Company	Trenz Electronic GmbH
PCN Number	PCN-20231016
Title	KK0714-02 to KK0714-04 Hardware Revision Change
Subject	Hardware Revision Change
Issue Date	2023-11-06

2.1 #1 Changed milled height profile.

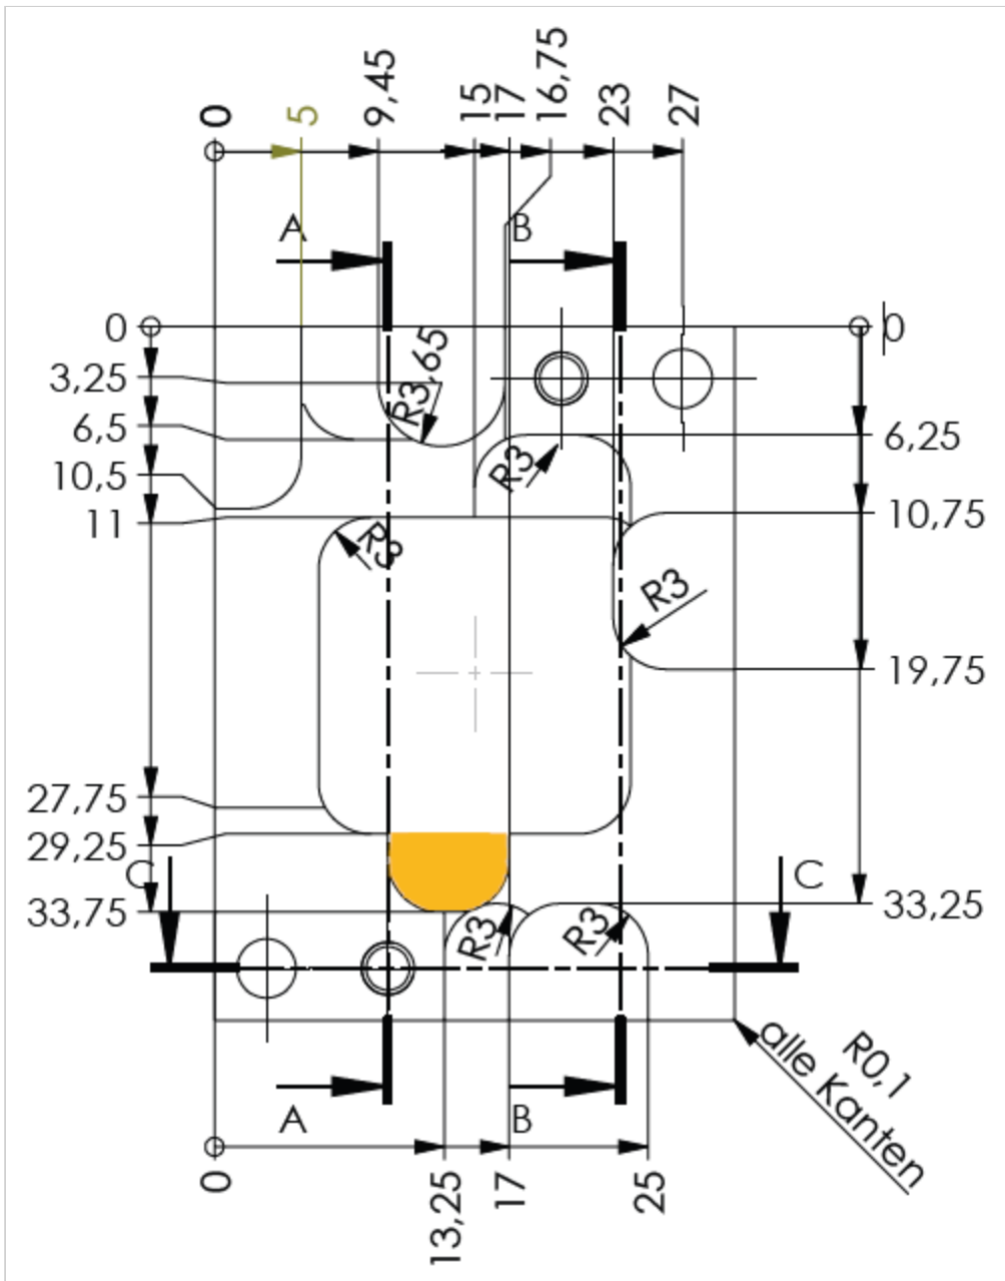
Reason: Revision 04 of TE0714 has different skyline and is therefore mechanical not compatible with KK0714-02.

Models with the feature marked in yellow are revision 04. Heatspreader without that feature are of older revision and not compatible to TE0714-04.

Impact: New heat spreader is compatible with TE0714-04, and also backwards compatible to older versions of TE0714.
